August 11, 2021

Version 3

Product Update: 2016–20 HR-V Software Update and CVT Inspection

Supersedes 21-046, Dated June 1, 2021, to revise the information highlighted in yellow.

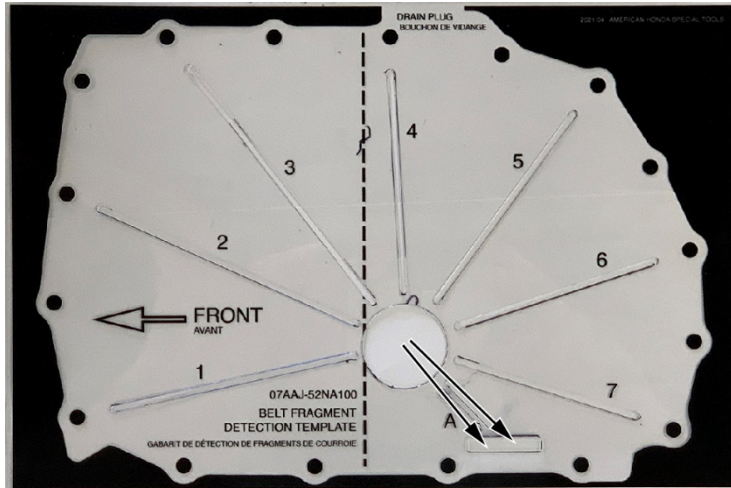
Under CVT INSPECTION, step 10 was updated, and image was added.

10. After tracing all 7 lines from the outside to the inspection area, let go of the magnet to see if it sticks in place. If the magnet sticks to the oil pan in the inspection area there is a problem with the transmission. Write the last 7 characters or digits of the VIN on the bottom of the oil pan. Take a clear picture of the magnet sticking to the oil pan in the inspection area, make sure the VIN characters are clearly seen in the picture, then go to service bulletin 21-047, *Warranty Extension 2016 - 20 HR-V CVT Premature Belt Deterioration*. If the magnet does not stick to the oil pan, go to the next step.
